Louisiana Energy Services, L. P.
National Enrichment Facility
NRC Docket No. 70-3103

Subject: Response to NRC Request for Additional Information Regarding the National Enrichment Facility Environmental Report

**Louisiana Energy Services
Response to April 29, 2004,
Request for Additional Information**

Figure ER RAI 2-1

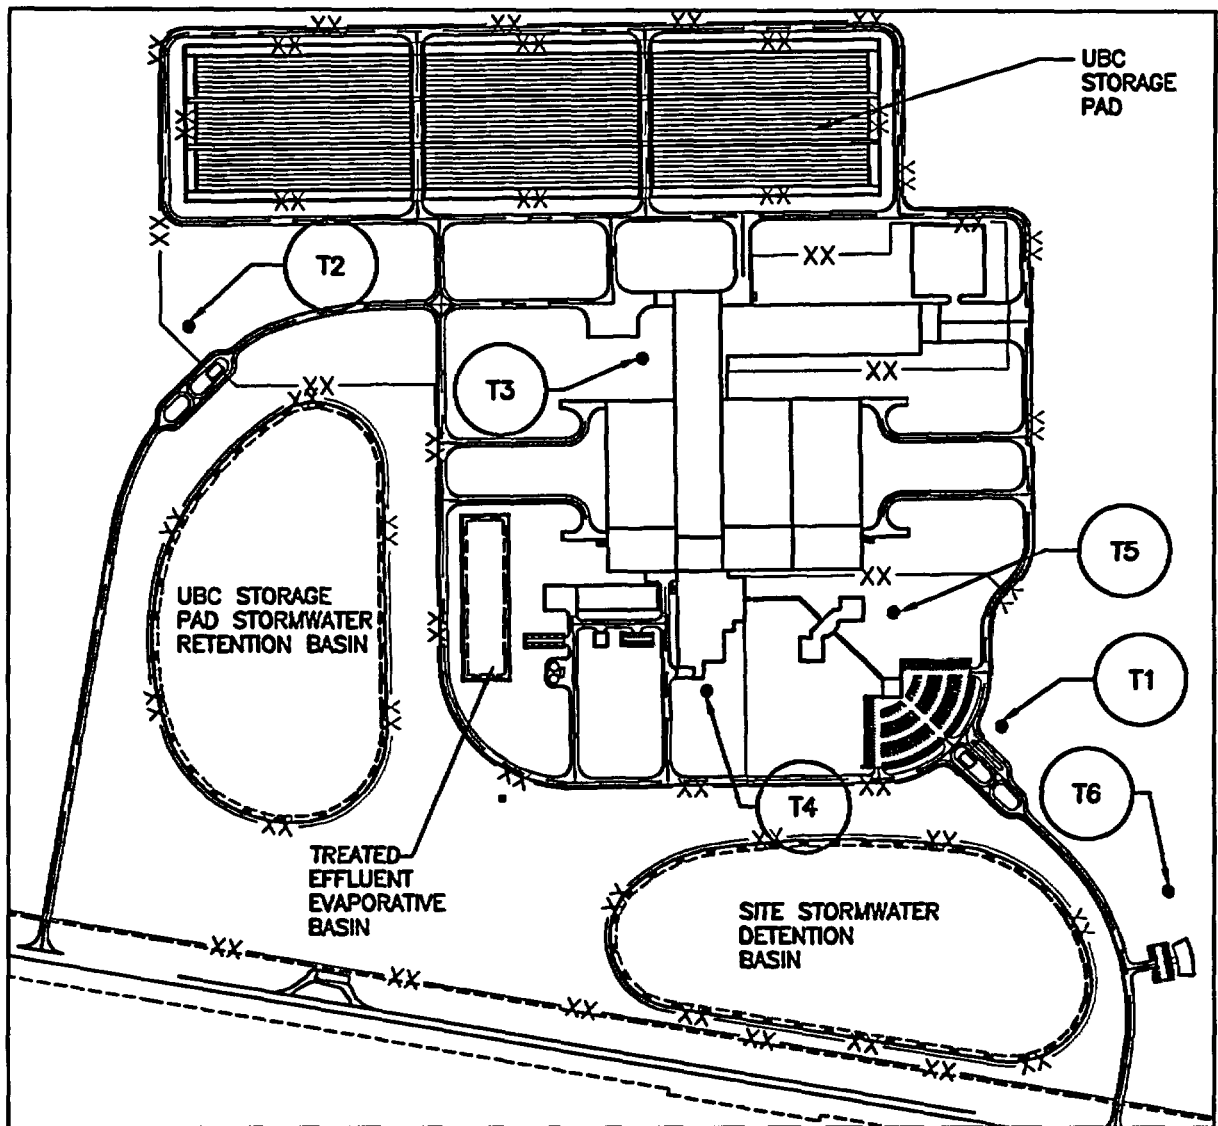
Provide a map or a figure to show the current CO₂ line location through the proposed NEF.

- Sections 2.1.2.1, 2.1.2.5, 4.1.1, and 4.1.2. state that the Trinity Pipeline, LLC, 10-in diameter, 2000 psi, underground CO₂ pipeline traverses southwest to northwest across the proposed NEF and would be re-routed but no maps show the current location of the pipeline.

The current location of the CO₂ pipeline is provided on Figure ER RAI 2-1, "Location of Current CO₂ Line," in Attachment 3 to this submittal. As shown in this figure and stated in ER Sections 2.1.2.1 and 2.1.2.5, the pipeline runs southeast-northwest, across the NEF site.

FIGURE ER RAI 2-2

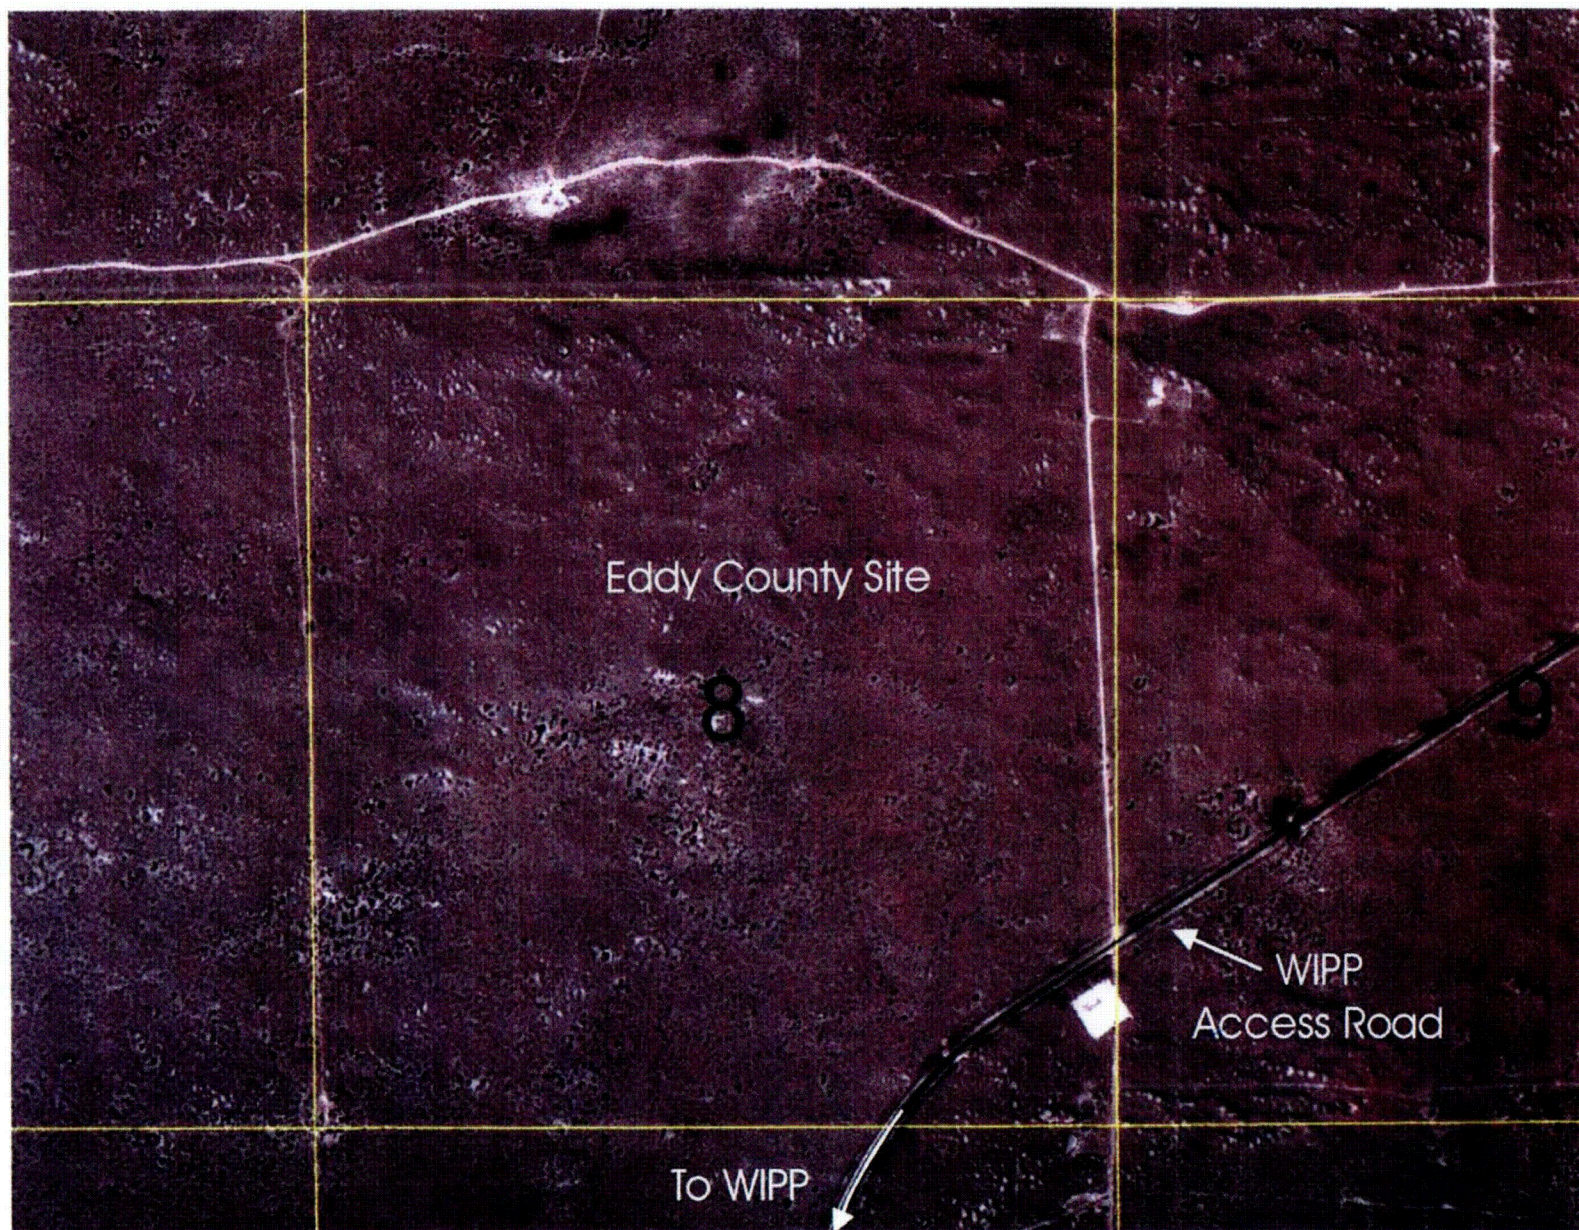
Provide a detailed description of the septic tanks and leach fields.

The design approach for disposal of sanitary wastes has been modified since the submittal of the ER. LES will incorporate a detailed description of the NEF septic systems in the next revision to the ER. Six septic systems are now planned in lieu of three septic tanks with a common leachfield. Each septic system will consist of a septic tank with one or more leachfields. Refer to Figure ER RAI 2-2, "Planned Septic Tank System Locations," in Attachment 3 to this submittal for the planned location of the six septic tank systems.

Figure ER RAI 2-7C.1

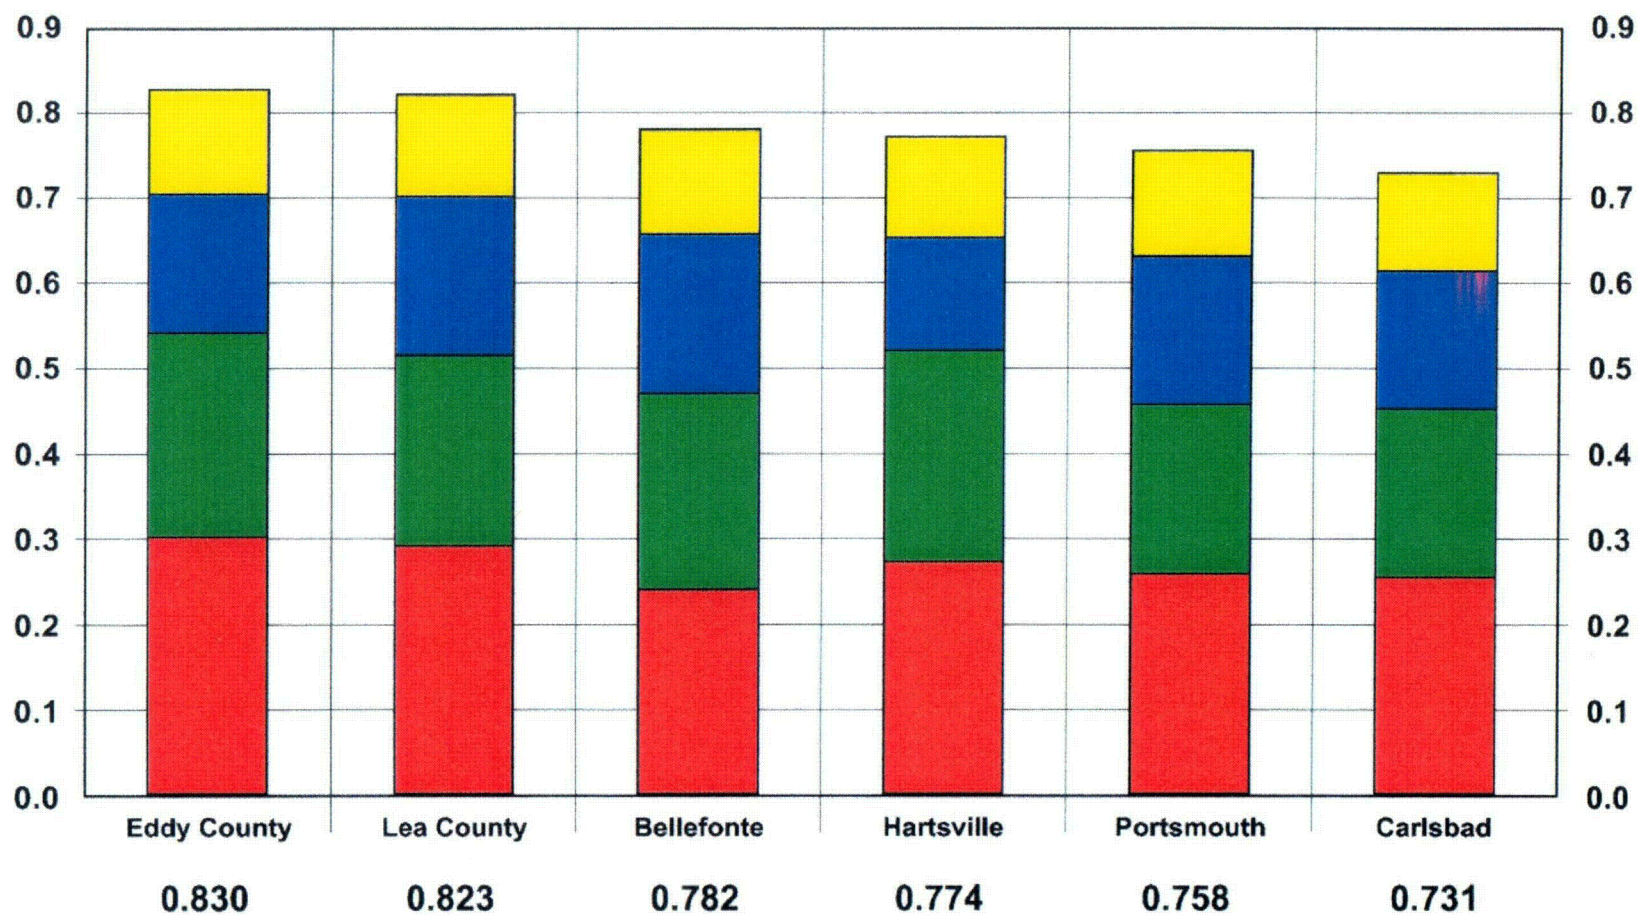
- C. Verify that the description of the Eddy County site is accurate in Section 2.1.3.3.4.2.
- The written description of the location of the Waste Isolation Pilot Plant (WIPP) access road and utilities indicate that the correct site is Section 11 of Township 22S, Range 31E of the New Mexico Meridian which is northeast of the current WIPP site. Section 2.1.3.3.4.2 identifies the Eddy County site as Section 8 of Township 22S, Range 31E of the New Mexico Meridian which is near the northwest corner of the WIPP site.

- C. The description of the Eddy County site in ER Section 2.1.3.3.4.2 is correct. Figure ER RAI 2-7C.1, "Aerial View of Eddy County Site," in Attachment 3 to this submittal provides an aerial view of the Eddy County site. As described in Section 2.1.3.3.4.2 and as shown on Figure ER RAI 2-7C.1, the main WIPP access road is on the southeastern edge of the site.

Comparison of WCS and Midland-Odessa Wind Direction Data

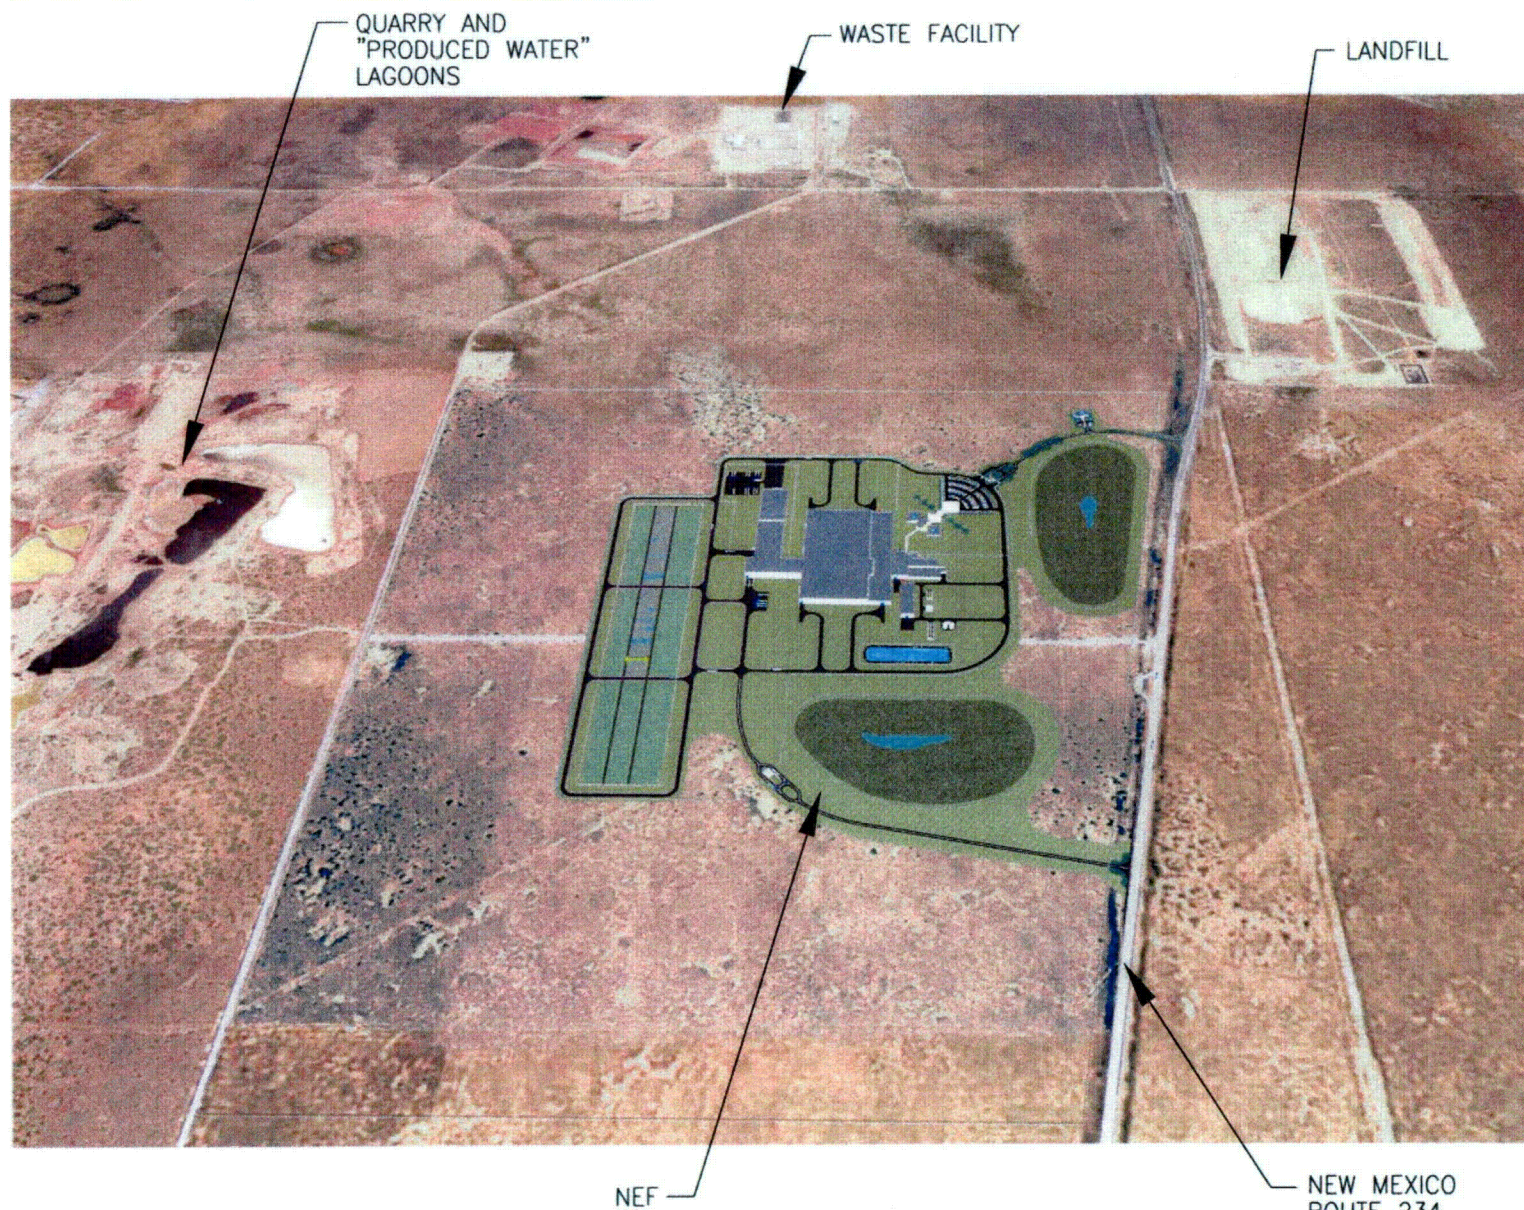
Provide the correlation analyses of the meteorological data from the Midland-Odessa, Texas Airport with the Waste Control Specialists (WCS) meteorological data.

As shown in Table ER RAI 3-3.1, the prevailing wind direction has a southerly component at both sites. Figure ER RAI 3-3, "Comparison of Wind Direction Data," provided in Attachment 3 to this submittal, provides a graphical comparison of the WCS and the Midland-Odessa wind direction frequency distribution. A comparison of the WCS and Midland-Odessa data provided in Table ER RAI 3-3.1 and in Figure ER RAI 3-3 shows good agreement in wind direction frequency between the two sites even though the meteorological data are from different time periods and the two sites are separated in distance and are at different elevations.

Figure ER RAI 4-1.2

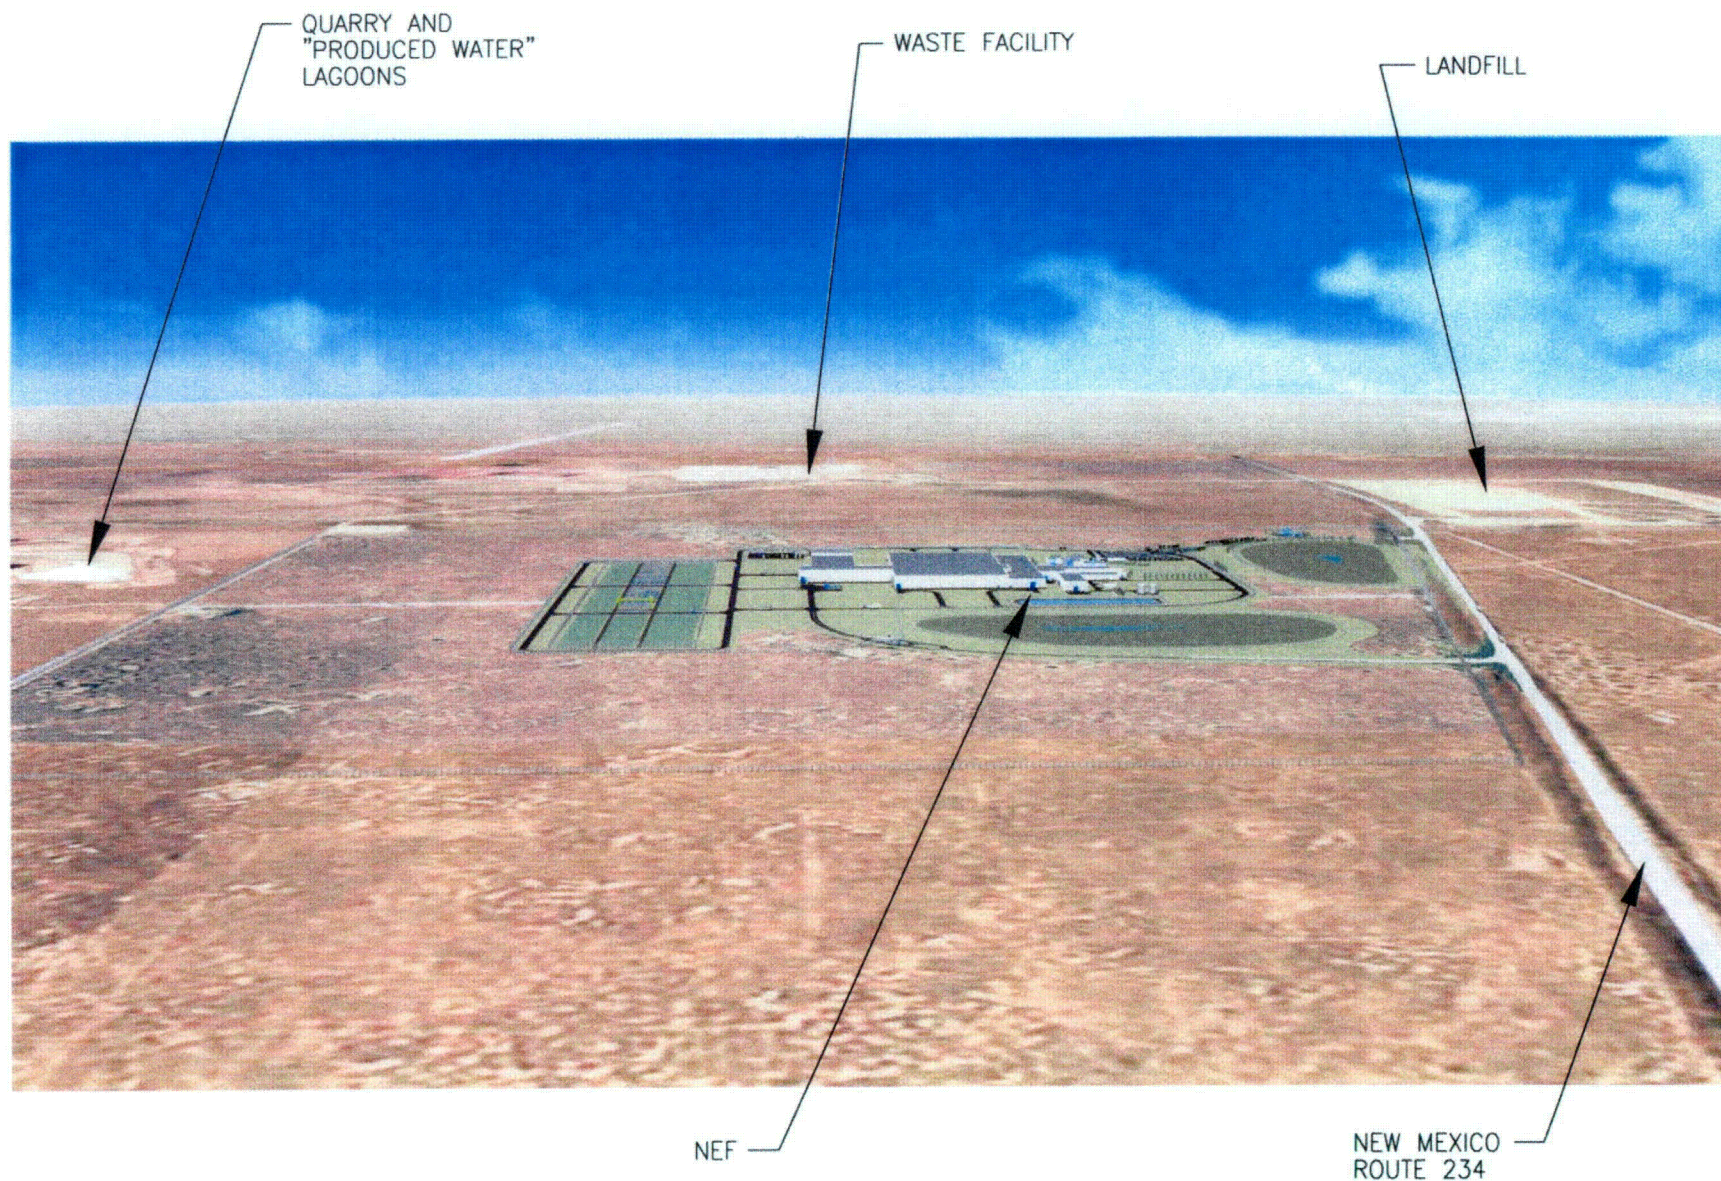
Provide a copy of the artistic rendering showing a view of the proposed NEF and how it would visually impact the site and surrounding area.

Figure ER RAI 4-1.1, "Aerial View," is an artistic aerial view of the NEF and surrounding area. Figure ER RAI 4-1.2, "View to the Northwest," Figure ER RAI 4-1.3, "View to the East," Figure ER RAI 4-1.4, "View to the South," and Figure ER RAI 4-1.5, "View to the West," in Attachment 3 to this submittal, provide artistic views of the NEF site and vicinity, looking to the northwest, east, south and west, respectively. The quarry and "produced water" lagoons to the north, the existing Waste Control Specialists (WCS) waste facility to the east, the county landfill to the southeast and New Mexico Route 234 to the south are shown in relation to the NEF site. Land to the west, occupied by a petroleum contaminated soil treatment facility, is undeveloped. Viewing the surrounding area from the NEF site, and looking northward, the quarry and "produced water" lagoons are at a higher elevation. To the east, several low-rise buildings associated with the WCS waste facility are apparent at a distance. Earthen mounds are apparent to the southeast, across New Mexico Route 234. No structures are visible on the adjacent property to the west.
